Aquatic Centre Condition Audit

Condition and compliance audit for an existing aquatic centre

Cleveland Aquatic Centre, July 19, 2023

Audit Reference	Cleveland Aquatic Centre
Job Number	0336
Audit Date	July 19, 2023
Auditor

SCUM GUTTER

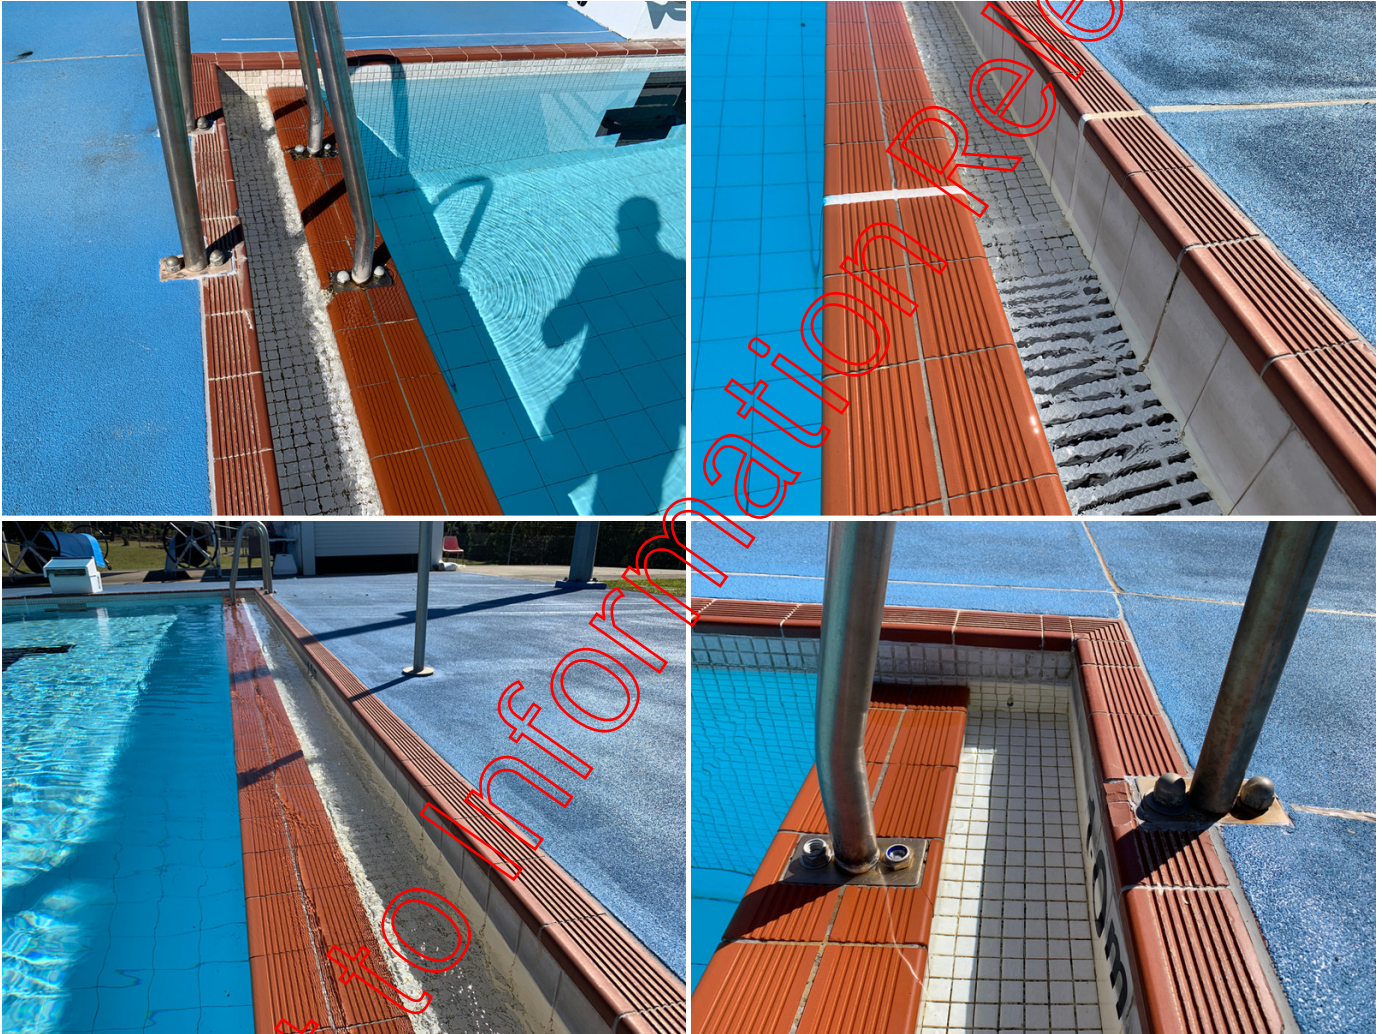
Observation Description	Scum Gutter
Observation Details	The scum gutter is of an aged design. The system is running full, indicating the flow is at maximum capacity. Additionally, more water is flowing over the northern wet edge, with this side being out of level along the length indicating structural movement of the pool.
Recommendations	Consider an upgrade to the 50m pool
Critical Item?	No

FILTERED WATER RETURN

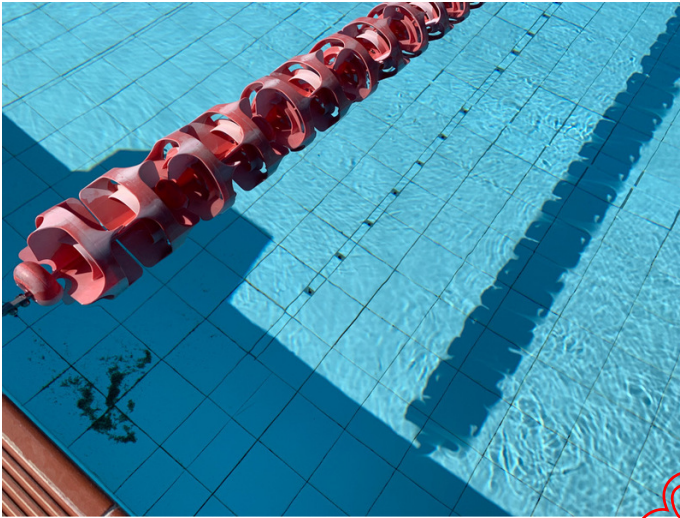
Observation Description	Filtered Water Return
Observation Details	Filtered water is delivered to a central channel along the pool which is fitted with small holes in the top to deliver water. This type of return will have little impact on pool circulation beyond the outlets.
Recommendations	Undertake a dye circulation test in accordance with the model aquatic health code to visualise and confirm the circulation. Undertake rectification works as required.
Critical Item?	No

RAMP COMPLIANCE

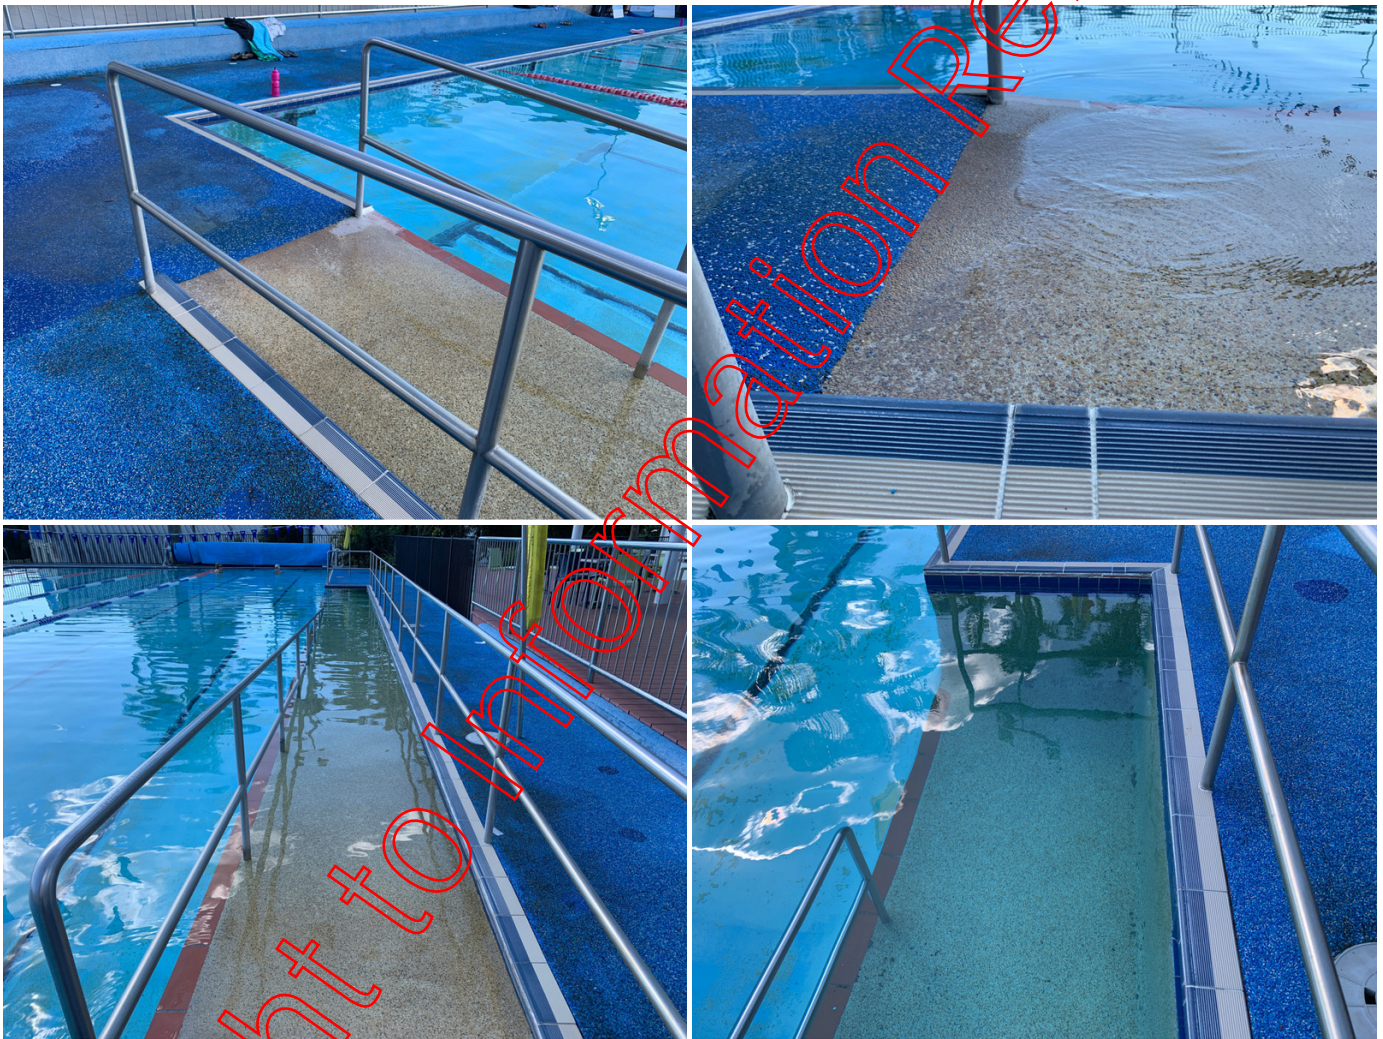
Observation Description	Ramp Compliance
Observation Details	The disabled access ramp is not compliant with AS1926.3: <ul style="list-style-type: none">o No mid landing is providedo Only one handrail is provided, with the other handrail being non-complianto The entry to the ramp is too steepo The ramp delivers too deep
Recommendations	Replace the ramp. In the interim, provide signage to inform patrons of the issues with the ramp.
Critical Item?	No

POOL FINISH

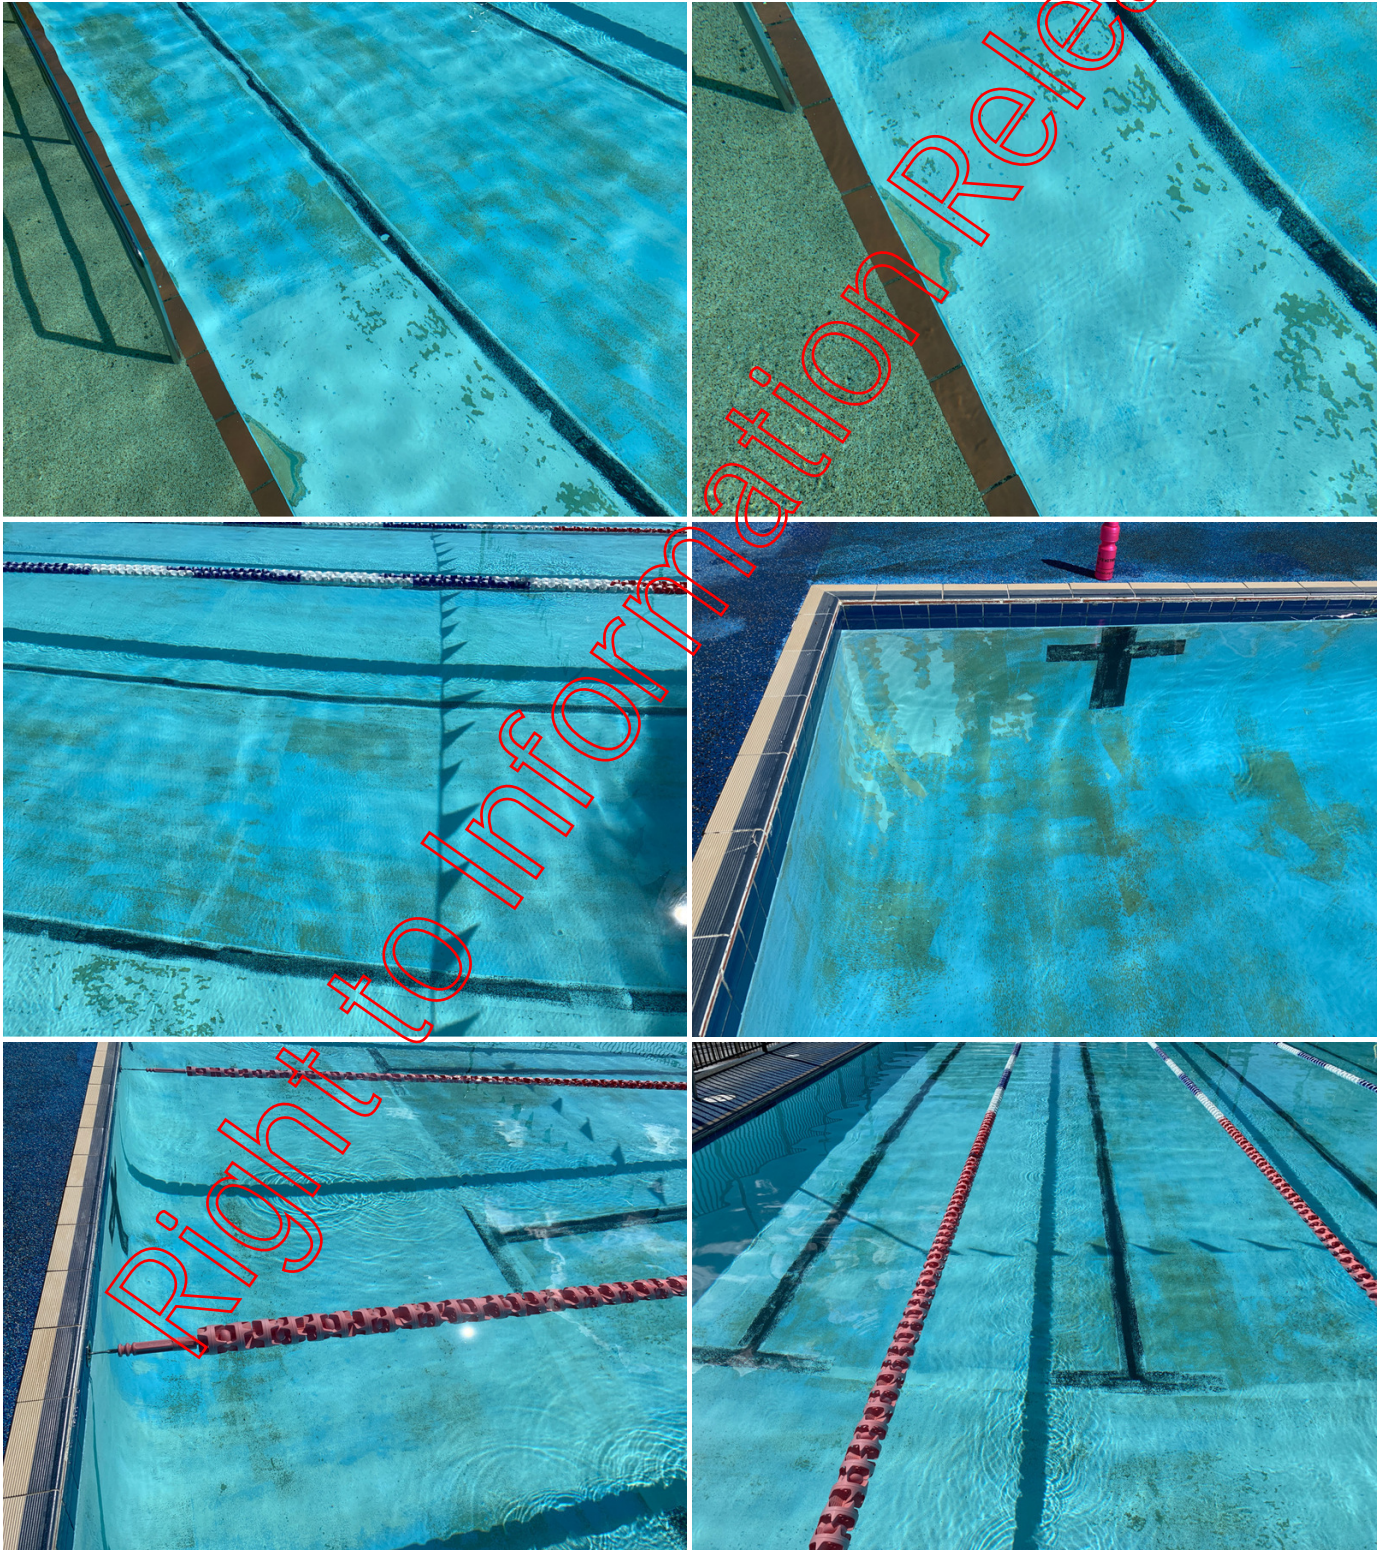
Observation Description	Pool Finish
Observation Details	The painted finish is in very poor condition with the underlying fibreglass liner appearing very worn in places.
Recommendations	Remove the fibreglass liner and refinish the pool
Critical Item?	No

CIRCULATION FITTINGS

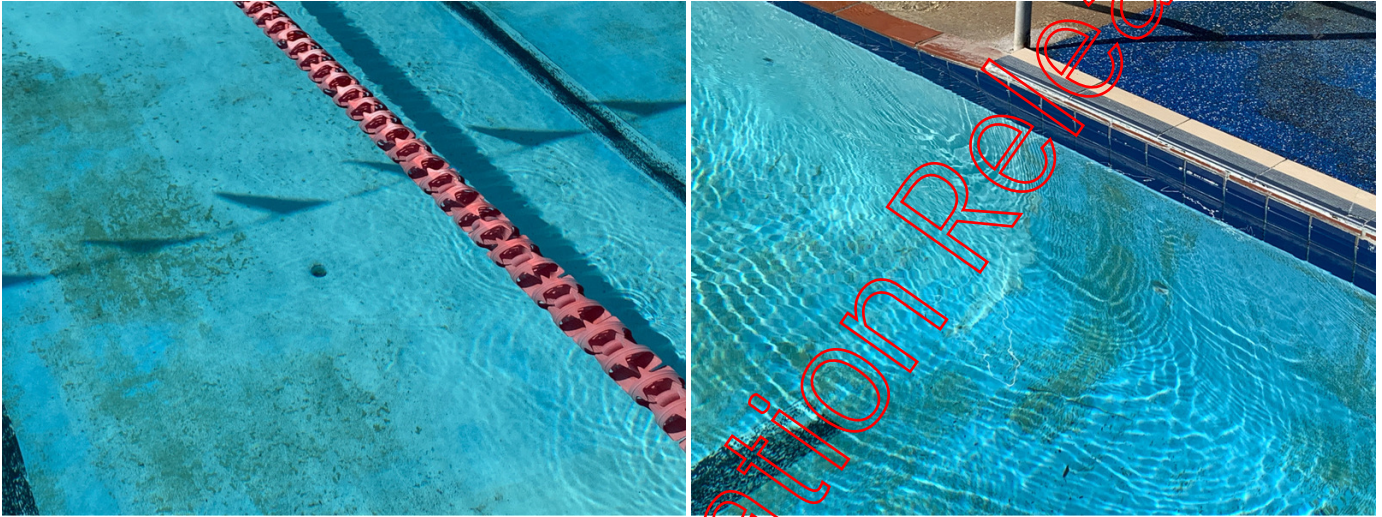
Observation Description	Circulation Fittings
Observation Details	The marjority of circulation fittings are missing in the pool with just bare pipe showing
Recommendations	Provide eyeball and floor rerun fittings to all bare pipes
Critical Item?	Yes

POOL CIRCULATION

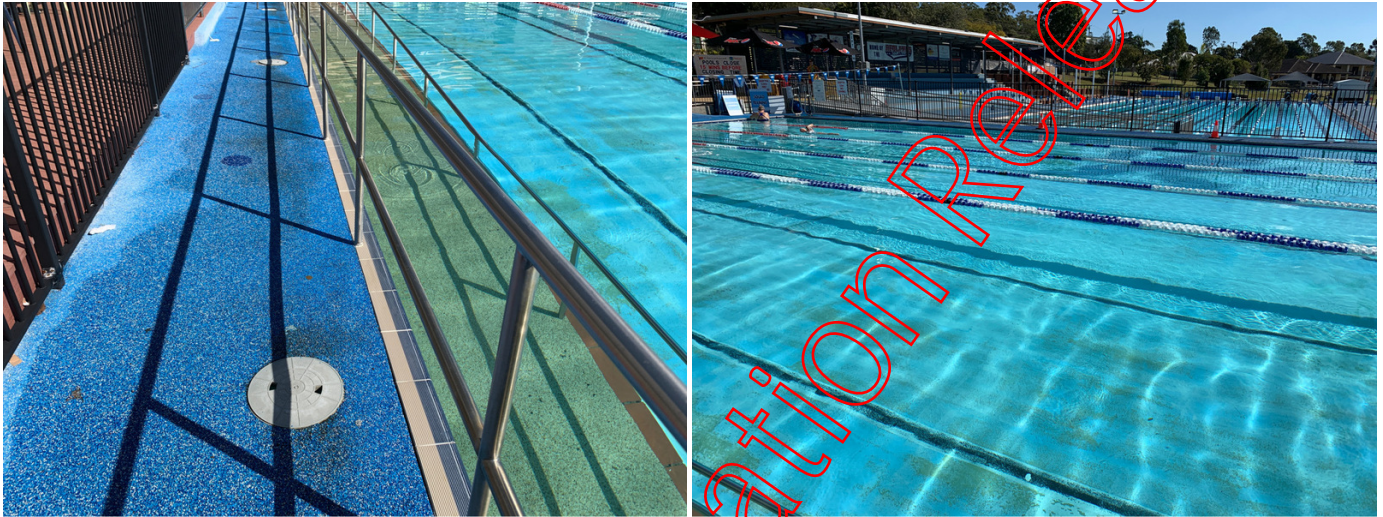
Observation Description	Pool Circulation
Observation Details	Circulation through the pool is likely poor due to the low flow and the poor number of fittings
Recommendations	As with the 50m pool, provide a circulation dye test
Critical Item?	No

FINISHES CONDITION

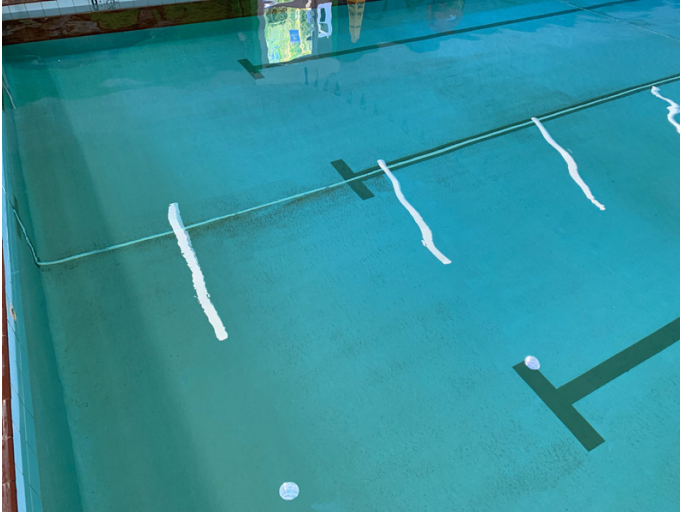
Observation Description	Finishes Condition
Observation Details	The finishes are in poor condition overall. The painted finish has failed with fibreglass visible through. Grout on the bench is generally missing whilst coping tiles are stained.
Recommendations	Replace the pool finishes
Critical Item?	No

POOL ACCESS

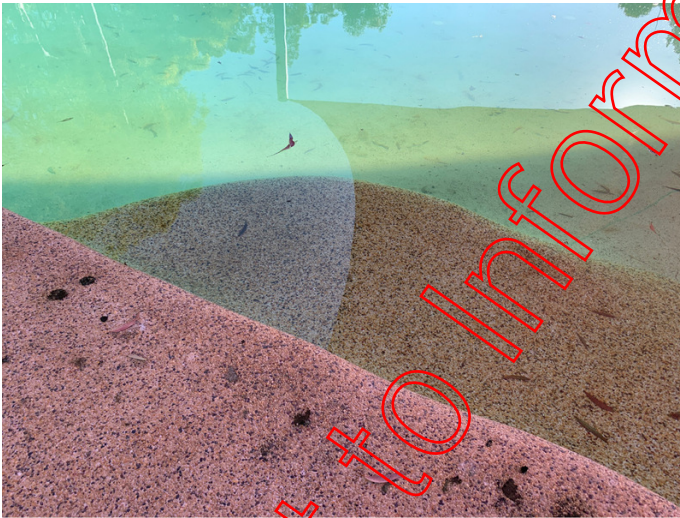
Observation Description	Pool Access
Observation Details	No compliant access point is provided in the deep end. A fibreglass step is present onto a swimout, however access does not continue to the flood of the pool nor are edge delineators provided to any steps or swimouts in the pool.
Recommendations	Add compliant ladders. Add edge delineation markers to all underwater edges.
Critical Item?	Yes

COPING FINISHES CONDITION

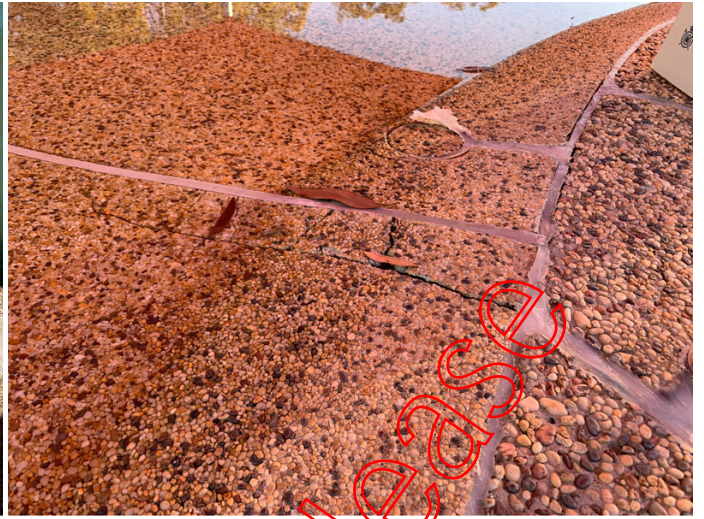
Observation Description	Coping Finishes Condition
Observation Details	The coping finishes condition is poor, with notable cracking observed in the finishes. In some areas sections of the finish are missing or delaminated.
Recommendations	Remove all finishes and inspect the sub grade for condition. Provide new finishes. In the interim, remove any loose areas and make good.
Critical Item?	Yes

STRUCTURE CRACK

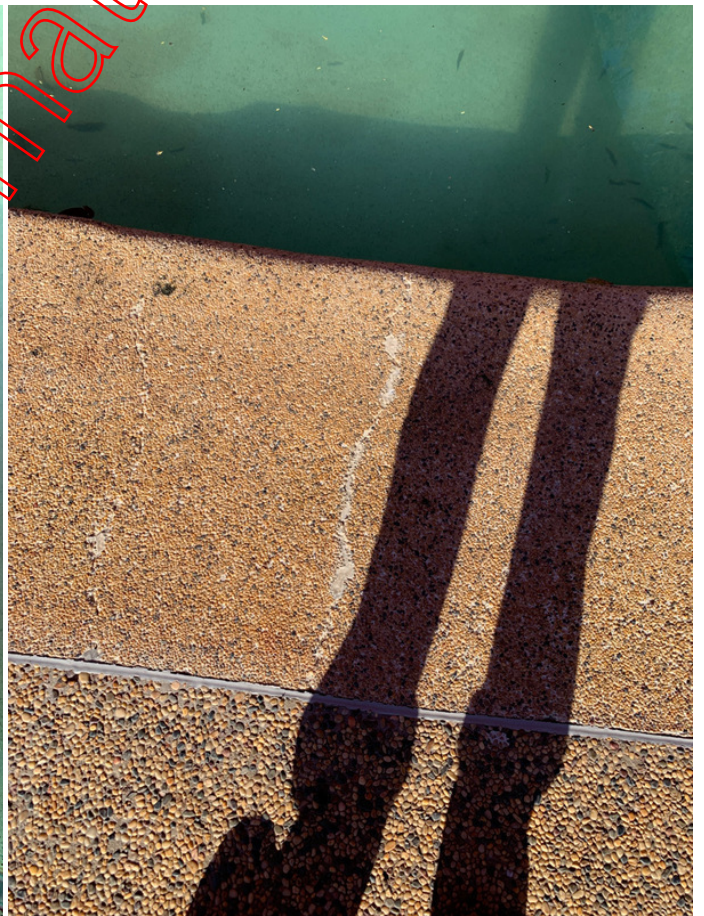
Observation Description	Structure Crack
Observation Details	A structural crack is observed running across the deep end of the pool
Recommendations	Inspect the crack for leaks and seal the crack
Critical Item?	Yes
Observation Photos
